UNITED STATES PATENT AND TRADEMARK OFFICE

APPLICATION NO.	FILING DATE	FIRST NAMED INVENTOR	ATTORNEY DOCKET NO.	CONFIRMATION NO.
10/580,859	03/01/2007	Walter Viegner JR.	102475.57672US	8826

Office Action Summary	Application No. 10/580,859	Applicant(s) VIEGNER ET AL.	
	Examiner STEPHANIE JENNINGS	Art Unit 4135

DETAILED ACTION

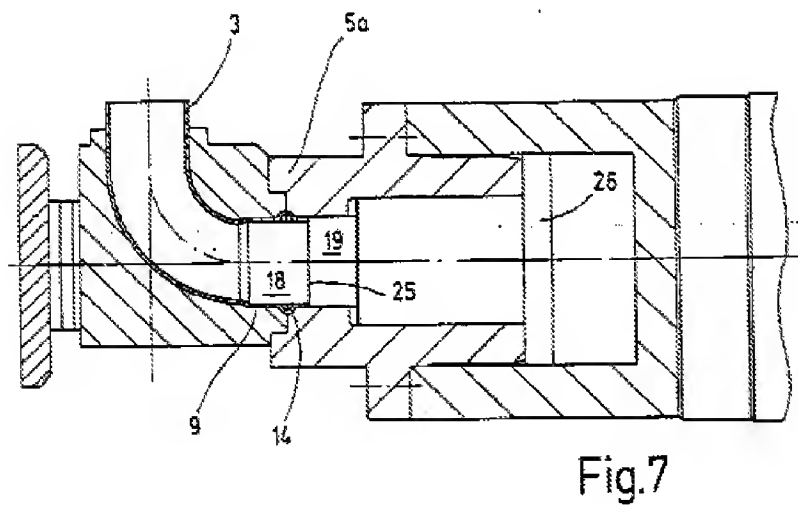
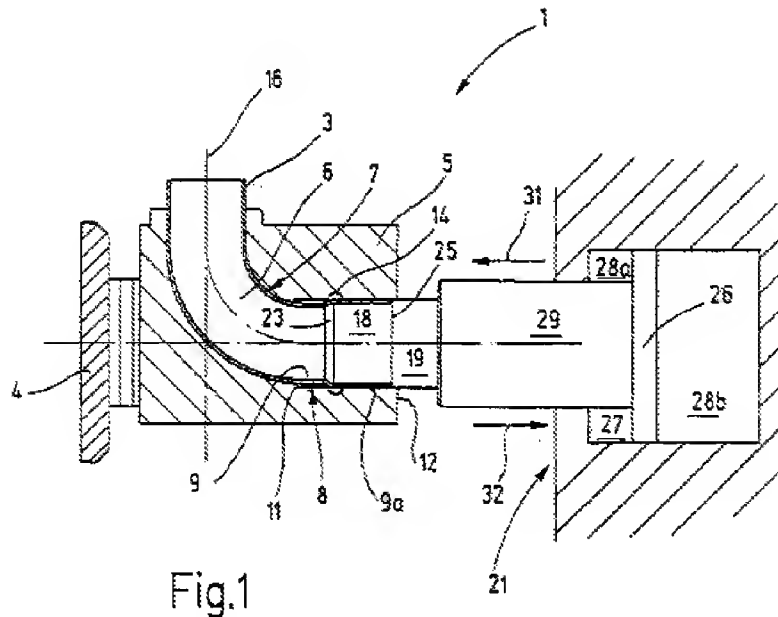
15. Limitations from claim 9, a method of making a socket on a pipe made of copper, by an at least single-step expansion of a pipe end with a large jump in diameter, comprising: introducing an expansion tool (18, 19, 21, 5, figure 1) axially into the pipe end (9), and at least partially upsetting a region to be expanded of the pipe end simultaneously with and/or

subsequently to introduction of the expansion tool into the pipe end by a force applied axially to the pipe end while limiting an outer diameter of the pipe end to be processed by at least one shaping shoe (5) at least partially surrounding the pipe end (page 1, paragraphs 3 and 10, page 2, paragraphs 11-12, and page 3, paragraph 34).

18. Limitations from claim 16, an apparatus for making a socket on a pipe end, comprising: an expansion tool which is axially introducible into the pipe end and which has one or more conical and cylindrical parts (8, figure 1) adapted to determine a subsequent inner diameter of the pipe end, at least one shaping shoe (5) having conical and cylindrical parts adapted to determine a subsequent outer diameter of the pipe end, and a substantially cylindrically structured upsetting

device (8, figure 1) having a smallest inner diameter which corresponds, with necessary play, to a maximum outer diameter of the expansion tool and a substantially radially extending annular shoulder which is pressable axially against an end face of the pipe end during an upsetting step (page 1, paragraphs 3 and 10, page 2, paragraphs 11-12, and page 3, paragraph 34).

20. Limitations from claim 18, the apparatus as defined in claim 17, wherein the inner diameter of the cylindrical part (8, figure 1) corresponds to a maximum inner diameter of the at least one shaping shoe (5, figure 1) (page 2, paragraph 16).

21. Limitations from claim 19, the apparatus as defined in claim 17, wherein an axial length of the cylindrical part (8, figure 1) is greater than or equal to a length of a cylindrical part of a shaping shoe (5, figure 1) which has a largest inner diameter (page 2, paragraph 17).

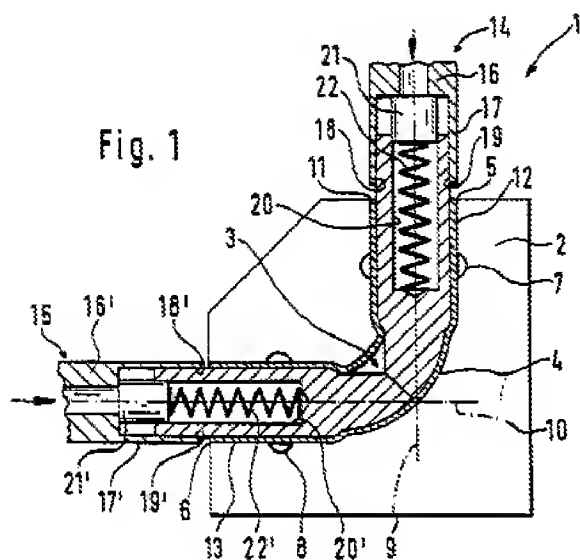
35. Limitations from claim 12, the method as defined in claim 9, wherein the upset pipe ends (12, 13, figure 1) are inwardly flanged for receiving sealing elements (93b, figure 1) (column 1, line 62-column 2, line 5).

36. Limitation from claim 14, the method as defined in claim 10, wherein the upset pipe ends (12, 13, figure 1) are inwardly flanged for receiving sealing elements (93b, figure 1) (column 1, line 62-column 2, line 5).

37. Limitations from claim 15, the method as defined in claim 11, wherein the upset pipe ends (12, 13, figure 1) are inwardly flanged for receiving sealing elements (93b, figure 1) (column 1, line 62- column 2, line 5).

38. It would have been obvious to one of ordinary skill in the art at the time of invention to combine Viegner's invention with Viegner's invention because inwardly flanging the ends of

the upset pipe allows for easier sealing during forming and ensures a more secure seal after the sealing elements are attached.
